Martin Place OSD DRP – Session 07 18.12.18:

Martin Place Metro

DRP - 8

METRO MARTIN PLACE | SOUTH TOWER

Tower built form relationships - DRP 07 Proposal

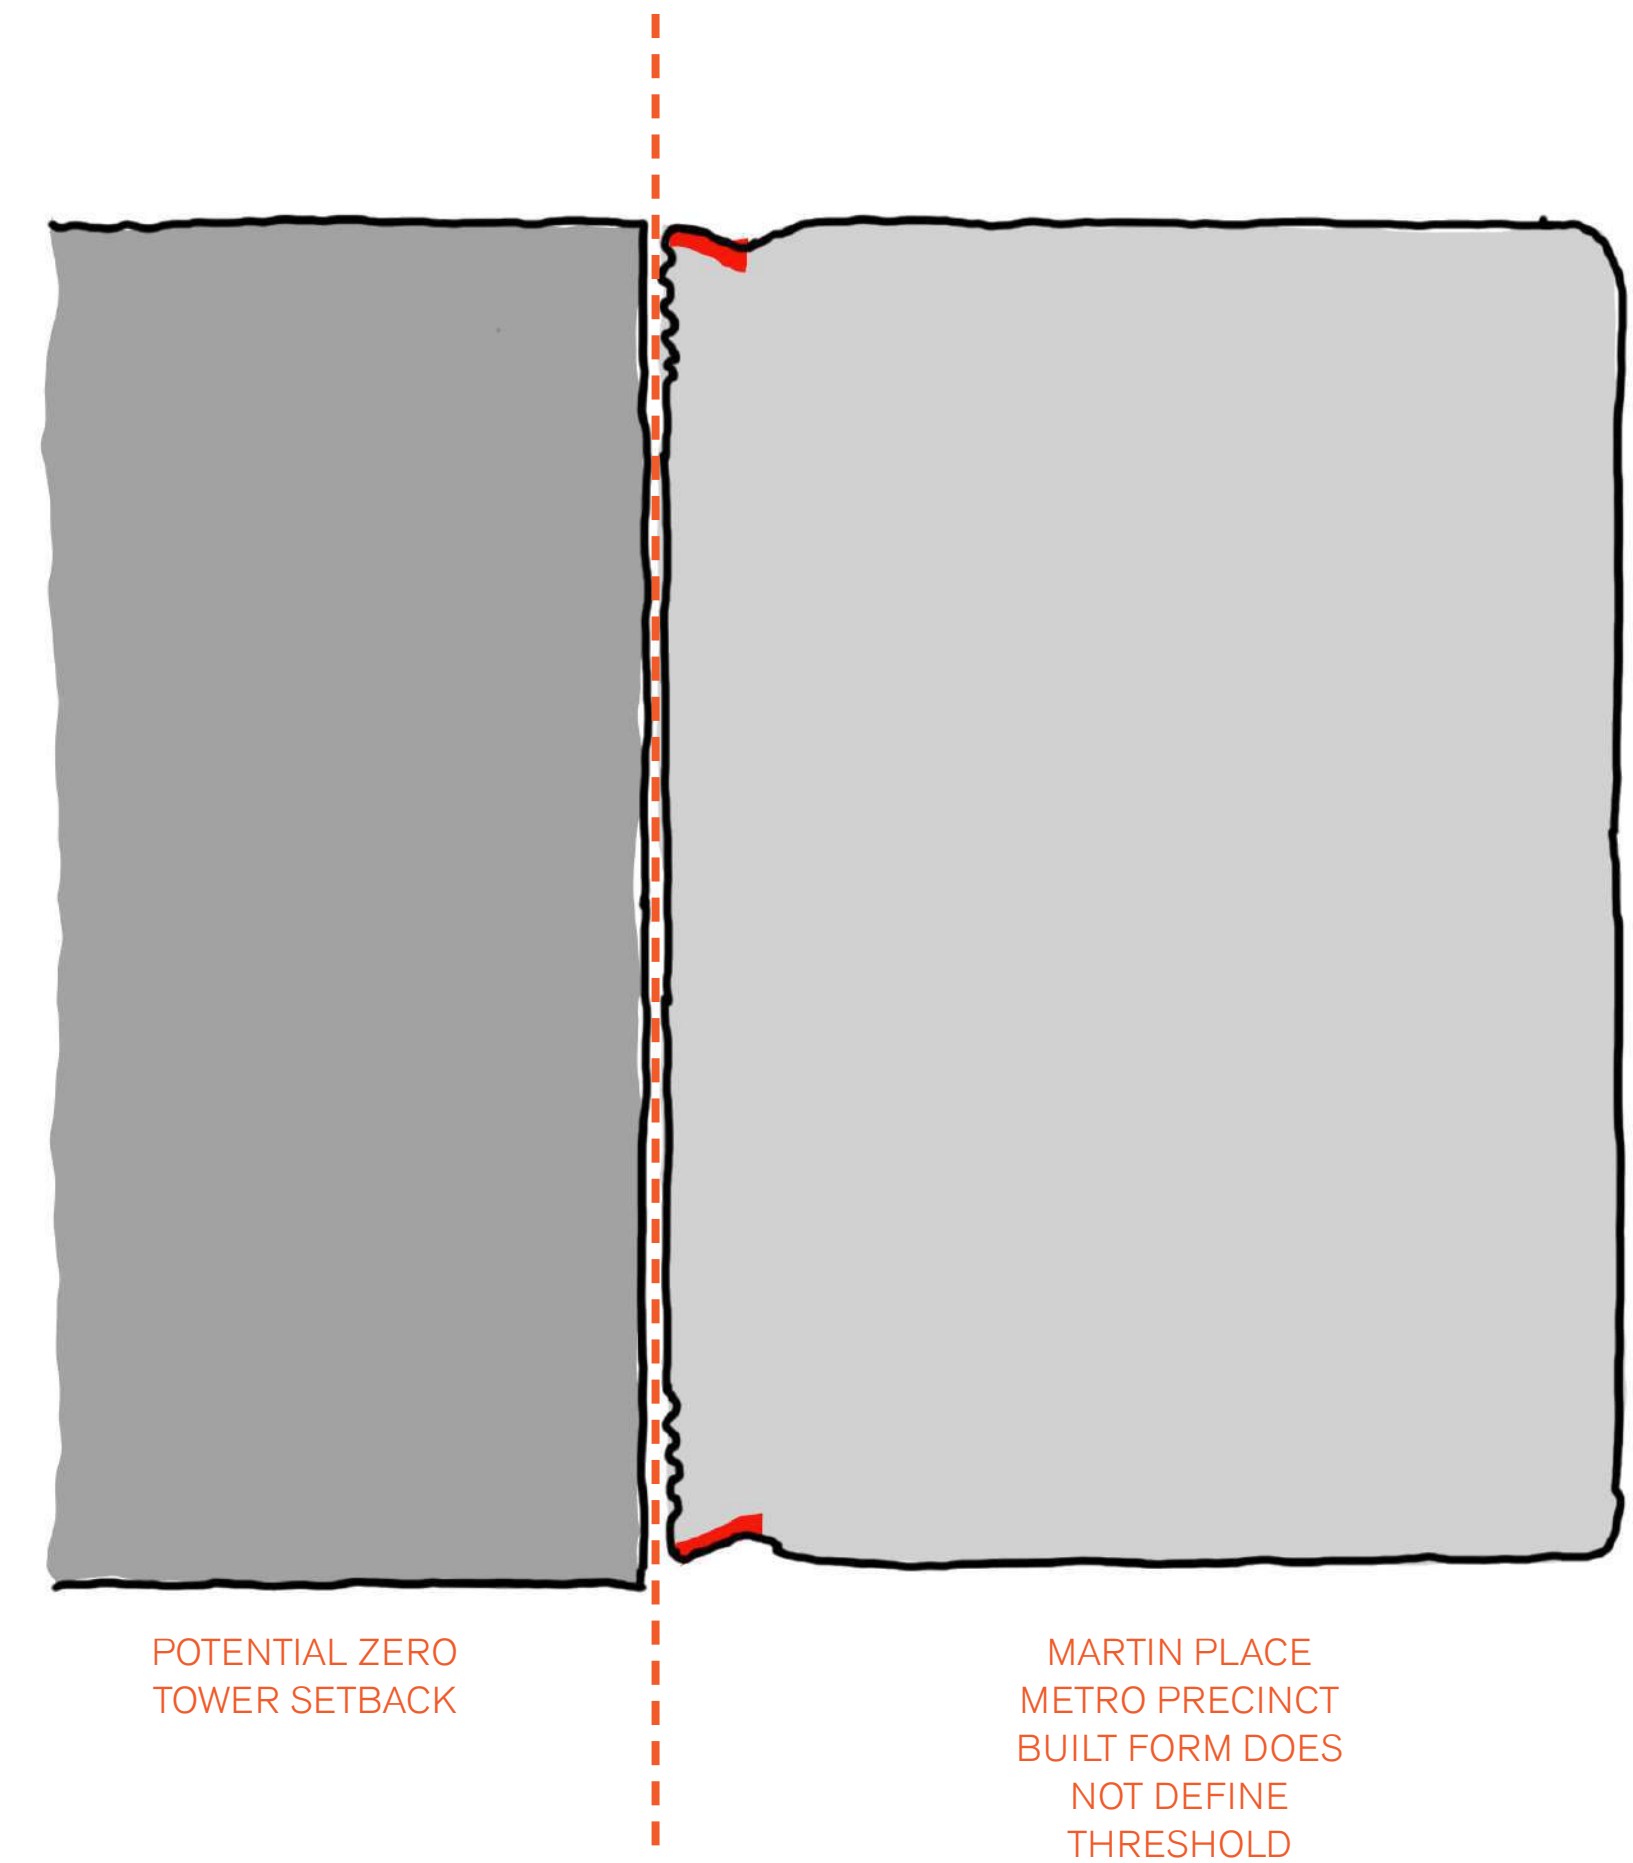
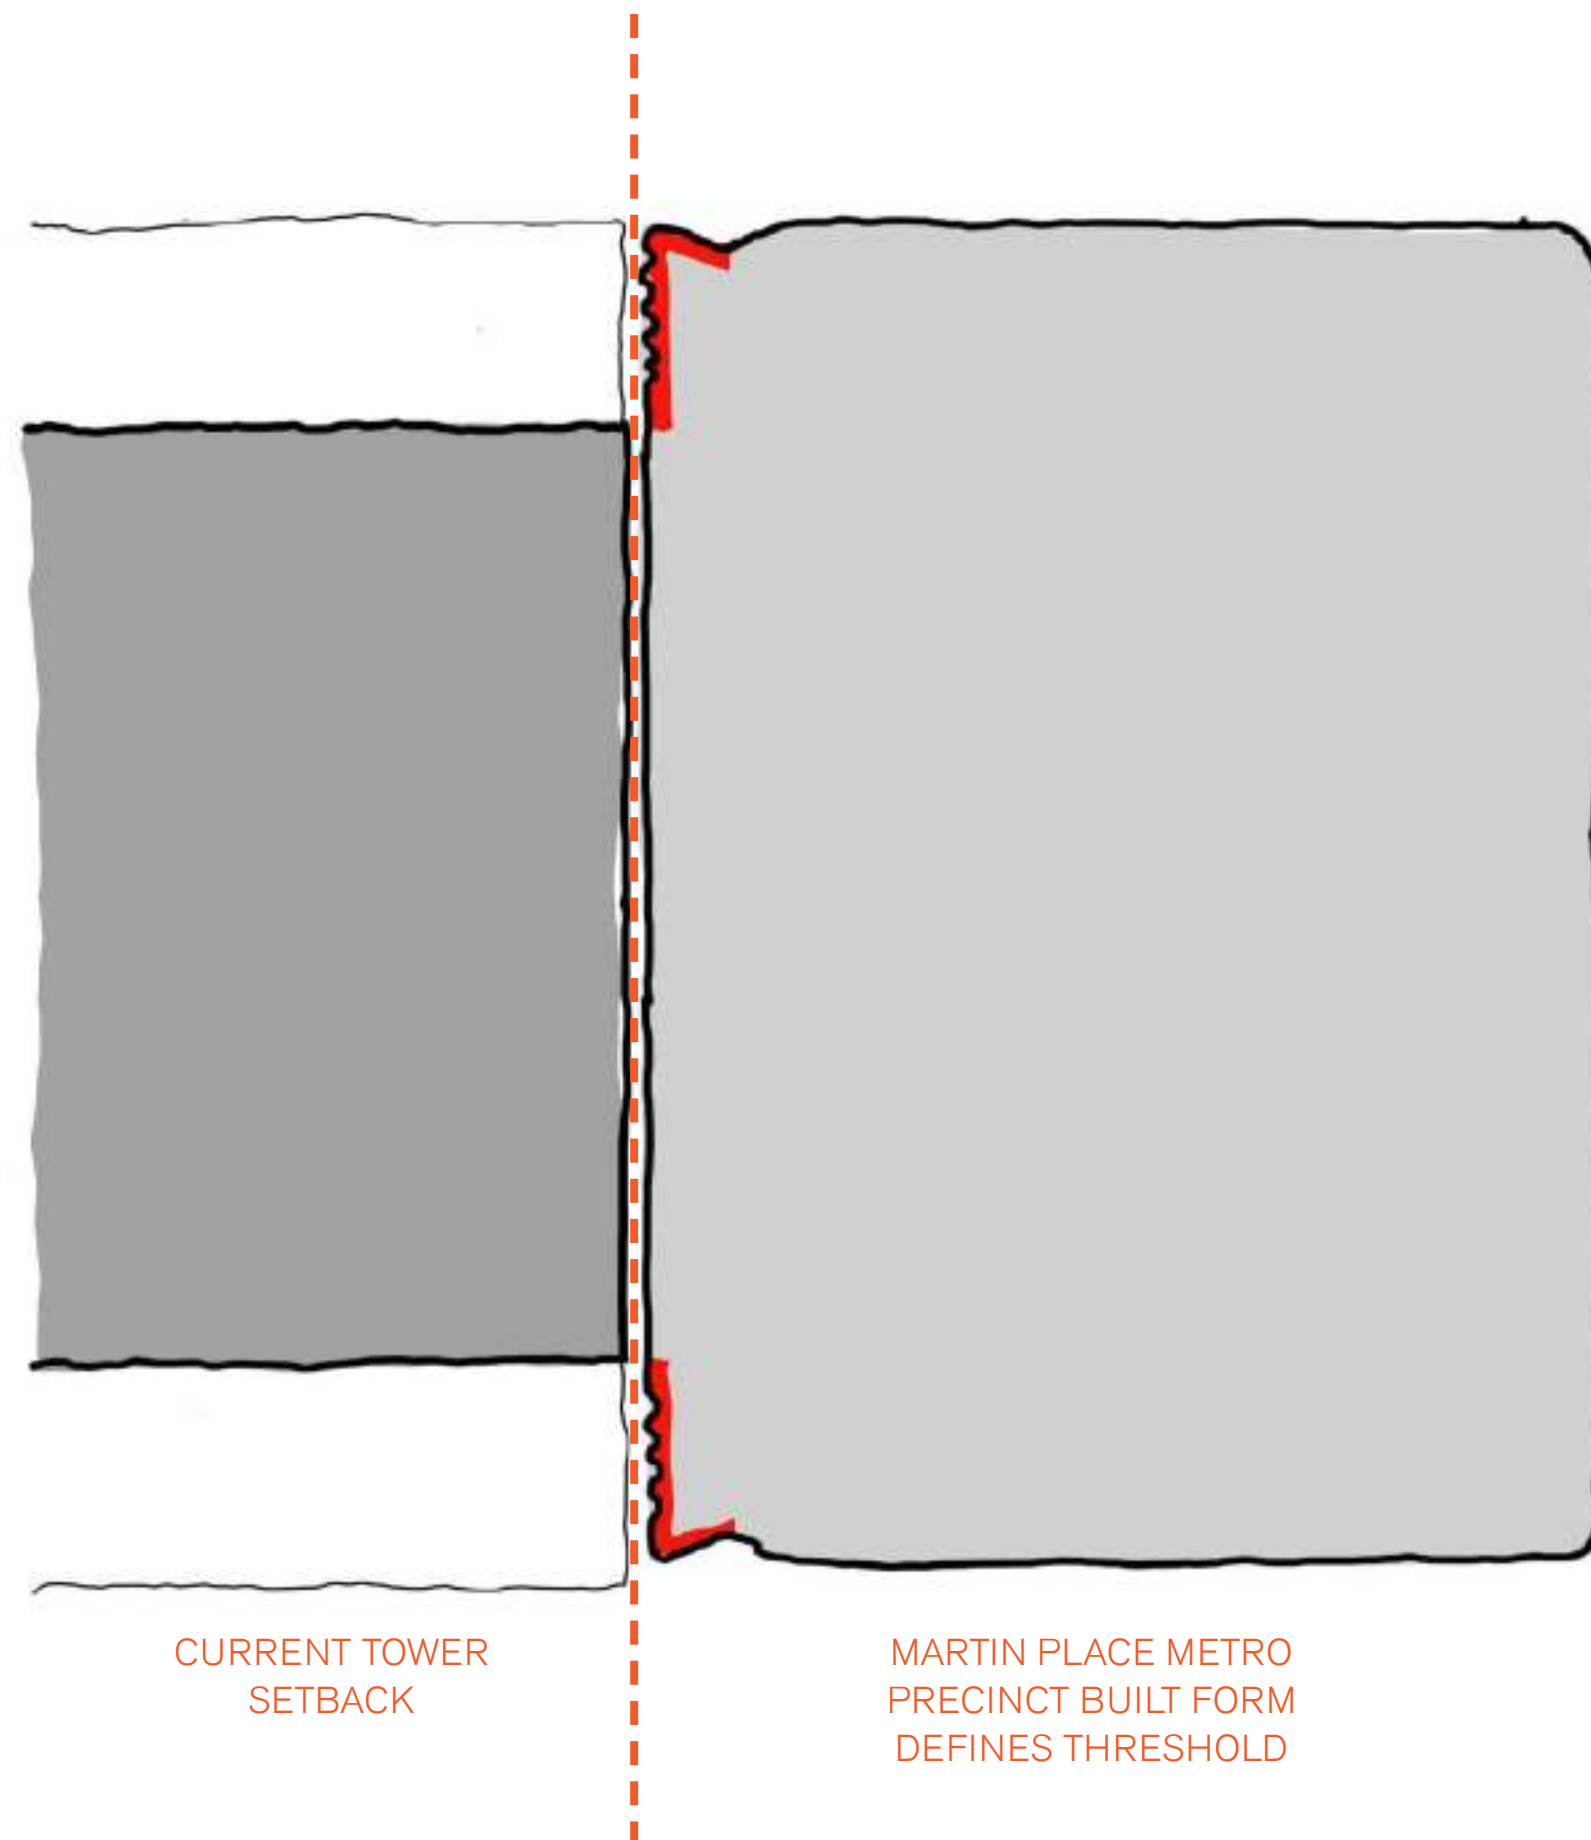
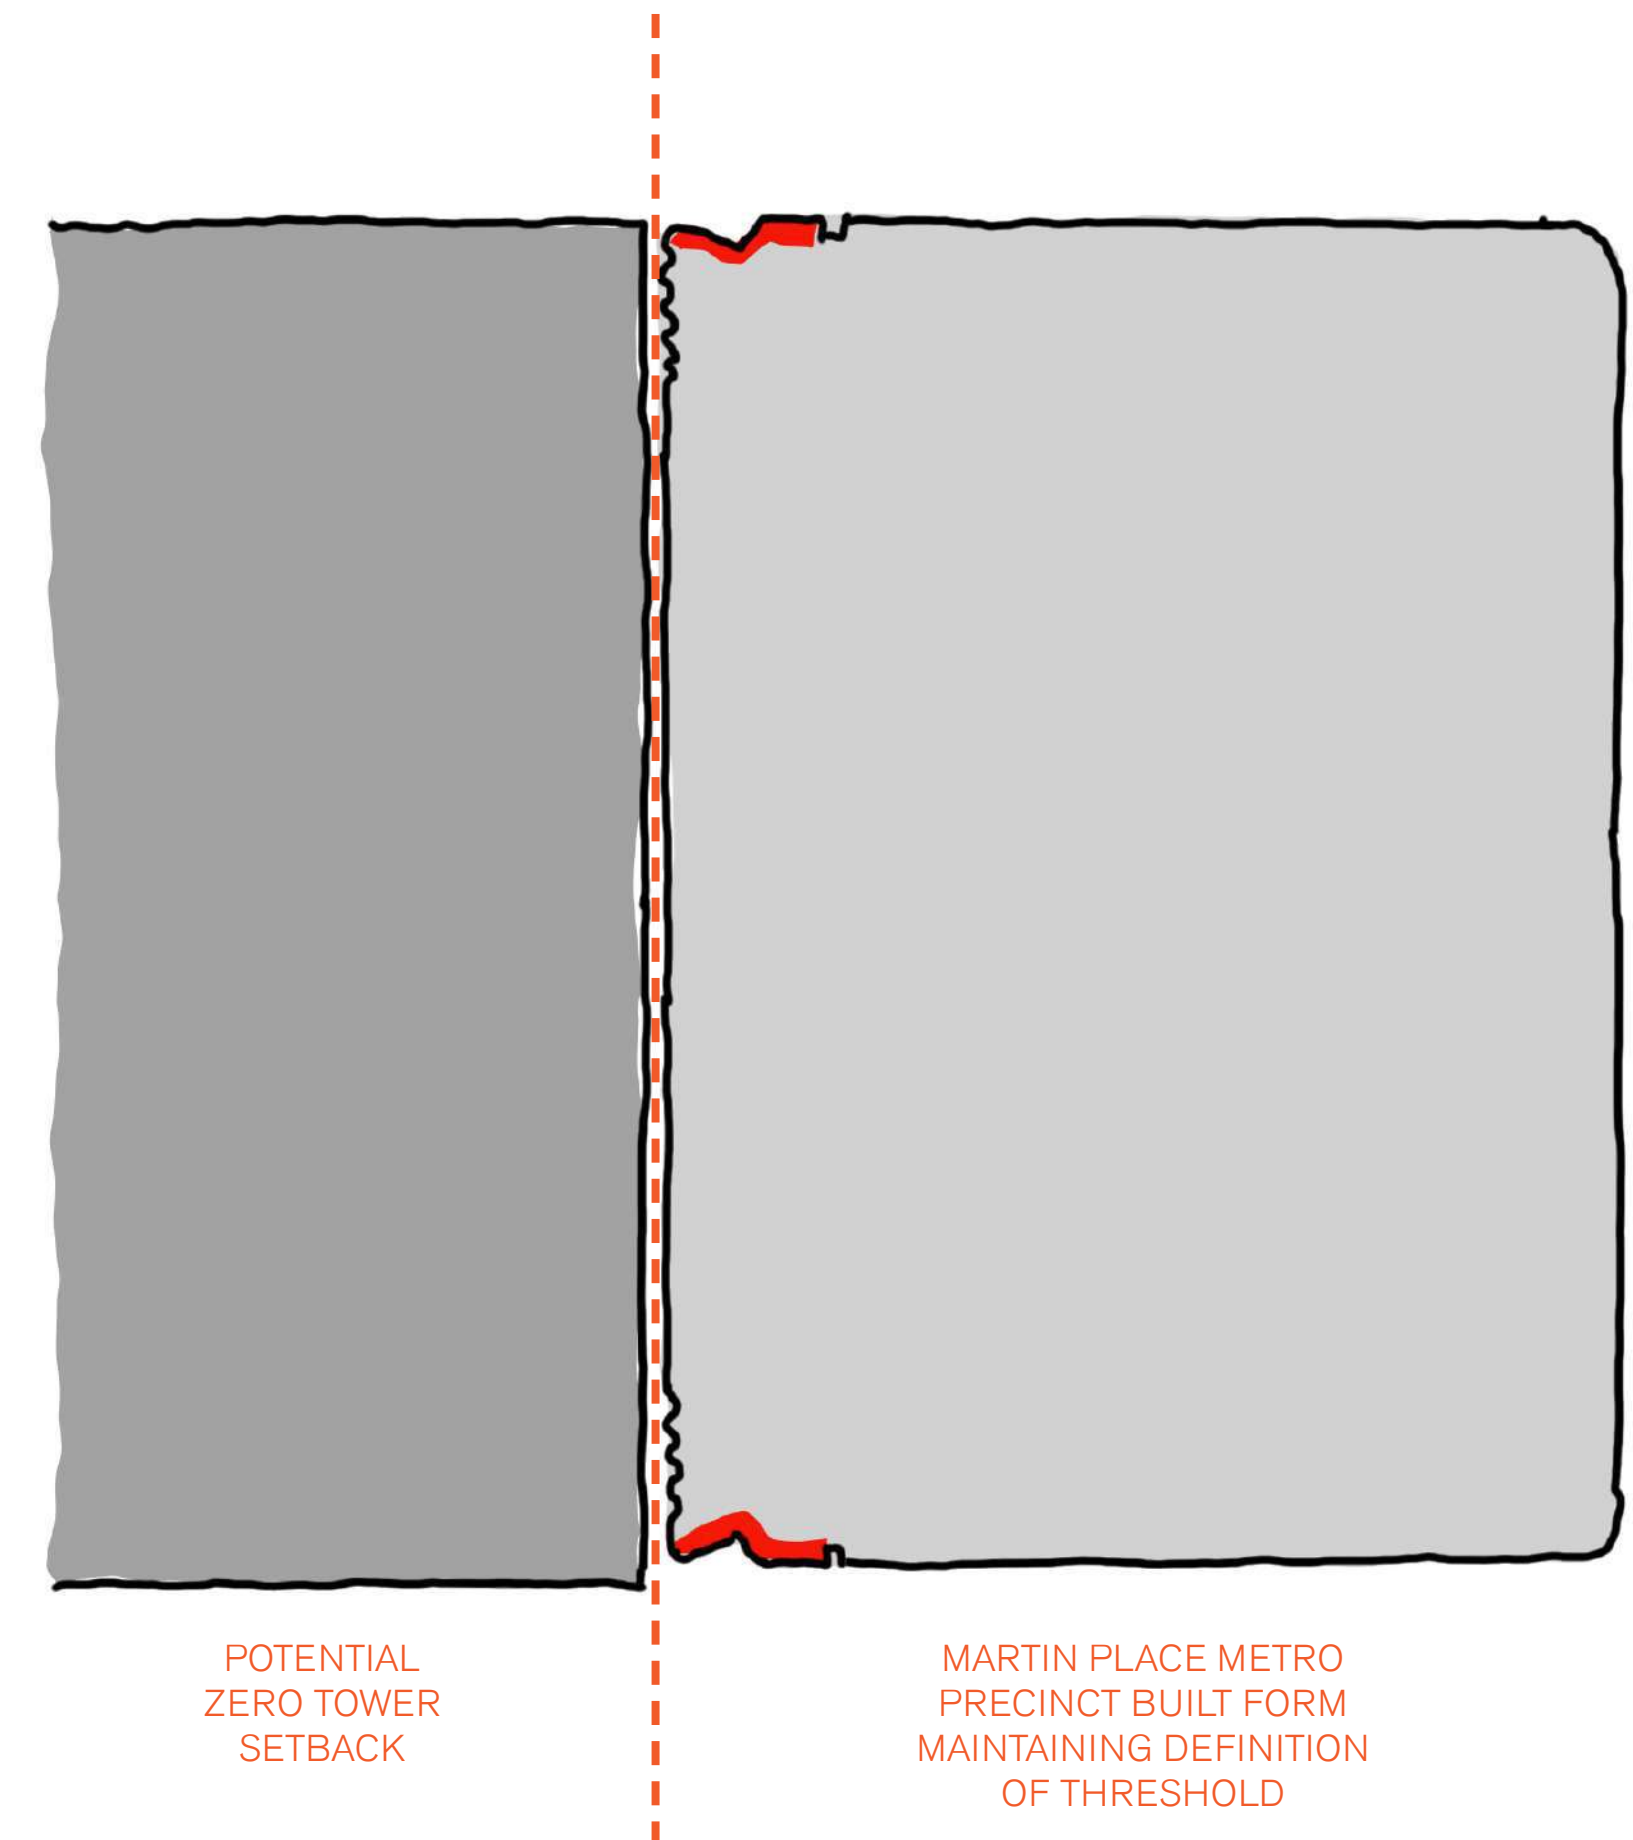
“While proposals to articulate and texture the tall southern facade go some way towards ameliorating the negative impacts of this wall, we remain concerned about its impact on urban design outcomes for the block. We note the tower floor plans above the podium level show more flexibility in the location of the structure than was previously understood which might allow articulation and detailing of the south east and south west corners of the tower to be reconsidered. Articulation of these corners would eliminate a continuous street wall, which would likely occur if future development to the south had no setbacks above the podium.”

_ Ensuring 39 Martin Place architecture at the S-E and S-W corners signify the threshold of the Martin Place and Martin Place Metro precincts.

_ Ensure integrity of southern facade, the S-W and S-E corner with the podium / tower architecture.
